George Zimmerman, CME Consulting, Inc.

Suspected Typographical Error in Figure 98-8 of IEEE 802.3bp-2016; Proposed late comment on 802.3cj D2.0, Subclause 98.5.5

Figure 98-8, Section 7, Page 227, Line 8.

Figure 73-9—Transmit state diagram

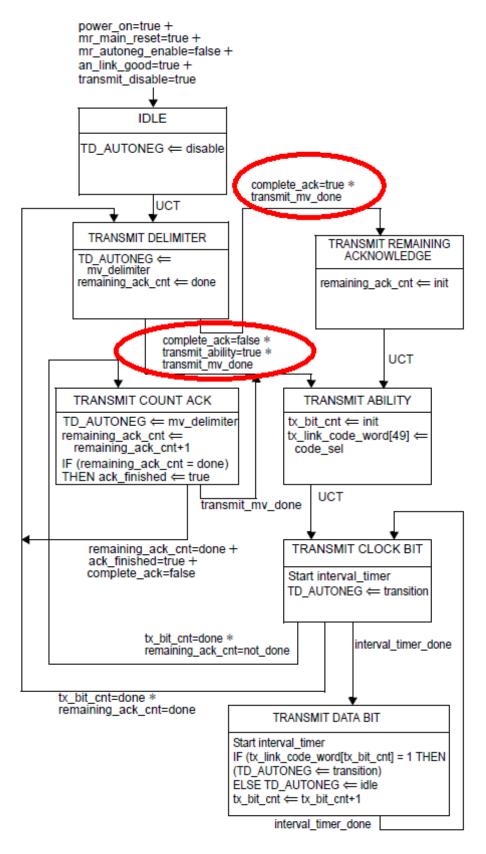
Clause 98 is based on Clause 73. There are some important differences but figure 73-9 shows the expected behavior for the state transitions that are common between them.

Marked up versions of Figures 73-9 and 98-8 follow, showing differences in what is similar logic between the two figures in red circles. OR's in the red circled transition logic of Figure 98-8 should be AND's.

Figure 98-8-Transmit state diagram

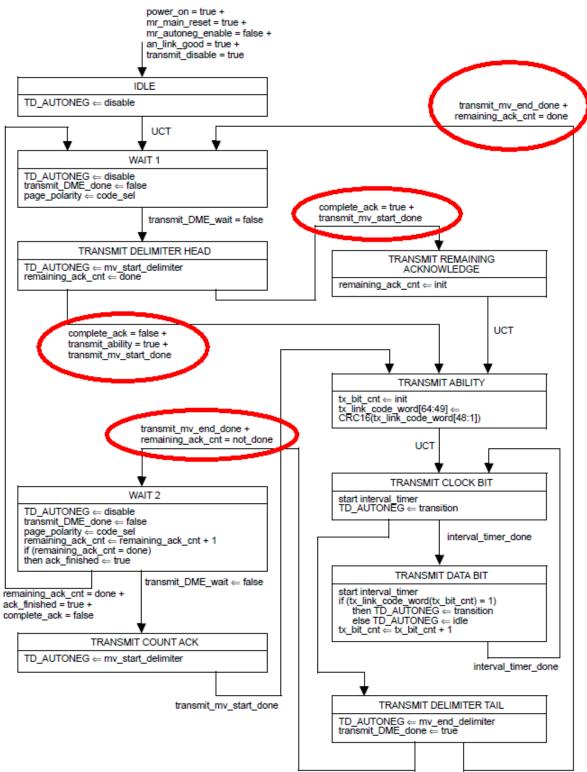
Figure 98-8 has several typos. On 4 transitions (5 places) an OR (+) is indicated for state transitions when the condition should be an AND (*) - line 8, 14,21 (&22) and line 28. Clause 98 is based on Clause 73. There are some important differences but Figure 73-9 shows the expected behavior for the state transitions that are common between them. (see figures attached as zimmerman_3cj_01_0817.pdf showing Figures 73-9 and 98-8). On 4 transition branches, "*" (AND) operators, appear to have been replaced with "+" (OR) operators.

I can only conclude this was a typo made on the implementation of comment 316 going from Draft 2.0 to Draft 2.1, which remained uncaught, for the following reasons:

Line 8: Change "transmit_mv_end_done + remaining_ack_cnt = done" to "transmit_mv_end_done * remaining_ack_cnt = done" on transition from TRANSMIT DELIMITER TAIL to WAIT 1)

Line 14: Change "complete_ack = true + transmit_mv_start_done" to "complete_ack = true * transmit_mv_start_done" on transition from TRANSMIT DELIMITER HEAD to TRANSMIT REMAINING ACKNOWLEDGE

Lines 22 & 23 (2 instances): Change "complete_ack = false + transmit_ability = true + transmit_mv_start_done" to "complete_ack = false * transmit_ability = true * transmit_mv_start_done" on transition from TRANSMIT DELIMITER HEAD to TRANSMIT ABILITY

Line 27: Change "transmit_mv_end_done + remaining_ack_cnt = not_done" to "transmit_mv_end_done * remaining_ack_cnt = not_done" on transition from TRANSMIT DELIMITER TAIL to WAIT 2.
